Evaluation of Physical Barriers – TUB-2

Address: Located in the median of State Route 91 freeway

Evaluation Date: 07-19-2021

FLOOR PLAN OF TUB-2

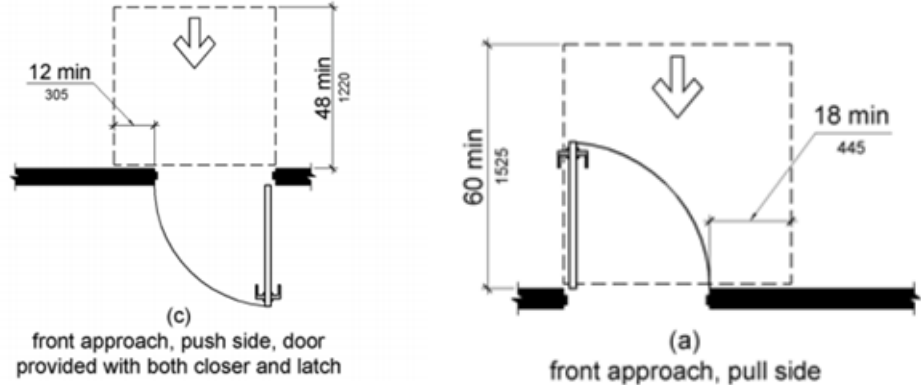
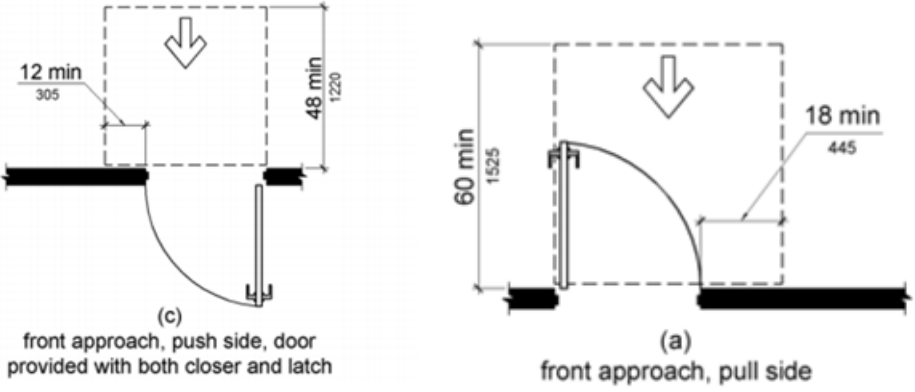
Issues/ Barriers Identified	Recommendations	Comments/ ADA Requirements
<p>1. Entry Doors</p> <p>i. International Symbol of Accessibility (ISA) sign is missing at the accessible entry door.</p> <p>ii. Maneuvering clearance for the main entry/exit door from inside is reduced by the fire extinguishing apparatus to 9 inches instead of the required 12 inches. Maneuvering clearance for the restroom door is also impeded.</p> <div data-bbox="211 510 1103 1094">  </div>	<p>Provide a tactile and visual sign containing raised characters and Braille lettering signs.</p> <p>Relocate apparatus to provide maneuvering clearances required for exiting the space and for entering the toilet room/ or provide automatic door openers</p>	<p>216.2 Designations. Interior and exterior signs identifying permanent rooms and spaces shall comply with 703.1, 703.2, and 703.5.</p> <p>404.3.2 Maneuvering Clearance. Clearances at power-assisted doors and gates shall comply with 404.2.4. Clearances at automatic doors and gates without standby power and serving an accessible means of egress shall comply with 404.2.4. EXCEPTION: Where automatic doors and gates remain open in the power-off condition, compliance with 404.2.4 shall not be required.</p> <div data-bbox="1650 540 2520 913">  </div> <p>Figure 404.2.4.1 Maneuvering Clearances at Manual Swinging Doors and Gates</p>

<p>2. Exit Doors</p>		<p>Single entry/exit door. See above.</p>
<p>3. Exterior Accessible route</p>		
<p>i. Handrail extension at top of ramp and stair does not comply with the minimum 12 inch extension requirement on either side. Bottom rail extension is OK.</p> <div data-bbox="226 1356 761 1780">  </div>	<p>Provide compliant handrail extensions.</p>	<div data-bbox="1687 1306 1998 1639">  <p>Figure 505.10.2 Top Handrail Extension at Stairs</p> </div> <div data-bbox="2262 1387 2635 1639">  <p>Figure 505.10.1 Top and Bottom Handrail Extension at Ramps</p> </div>
